Manual 15

Biennial Review Changes

M15 Biennial Review

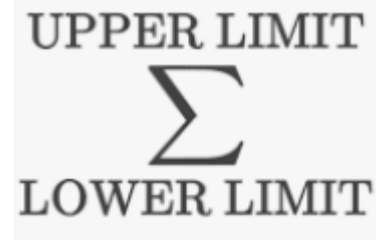
Move up to correct location

~~Exhibit 26: Name to be determined~~

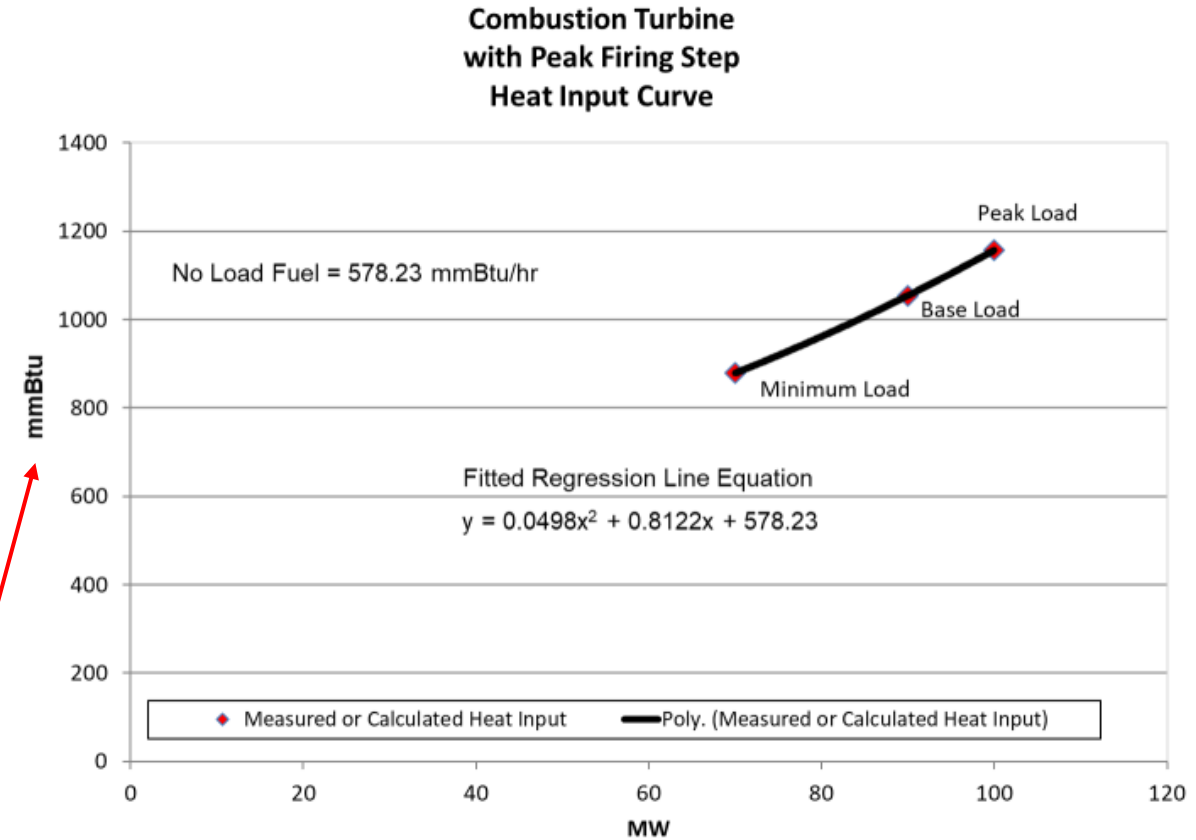
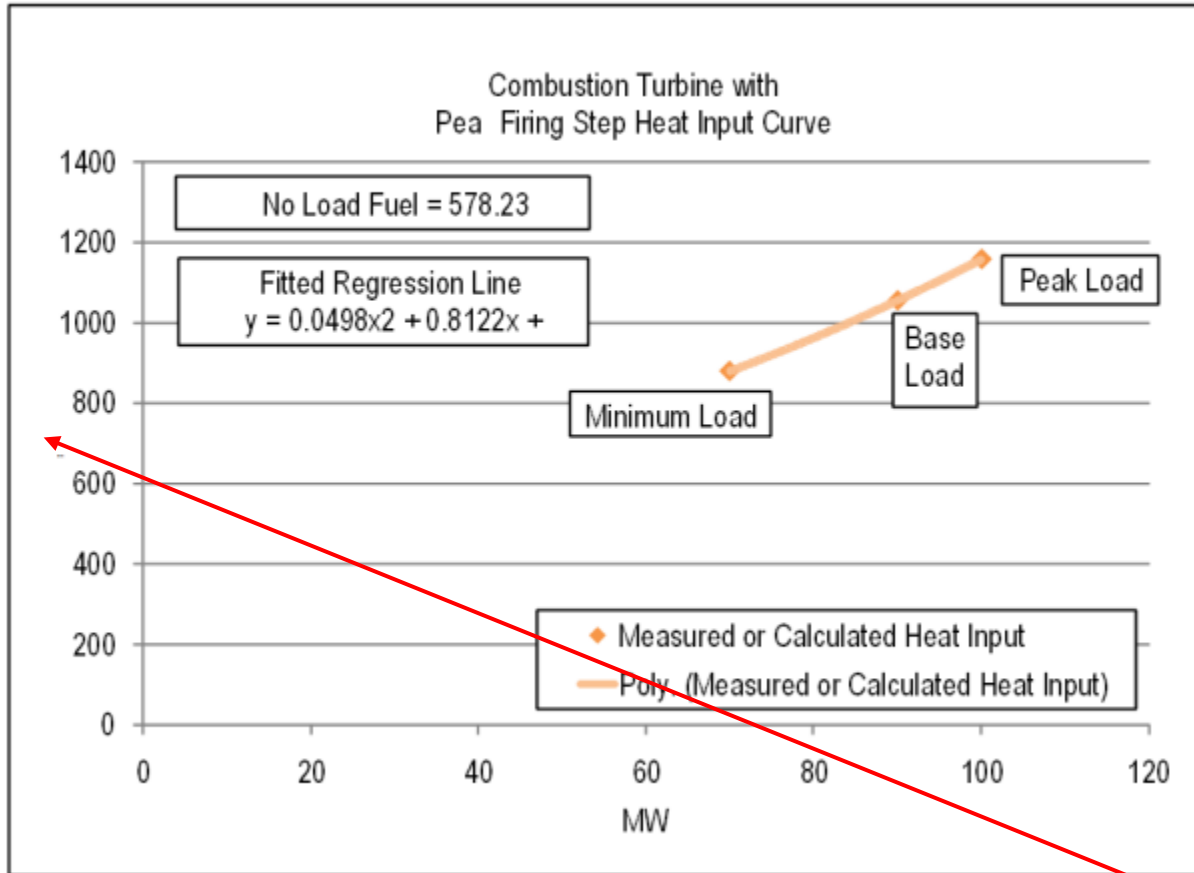
Replace any graphs with missing Y-axis labels
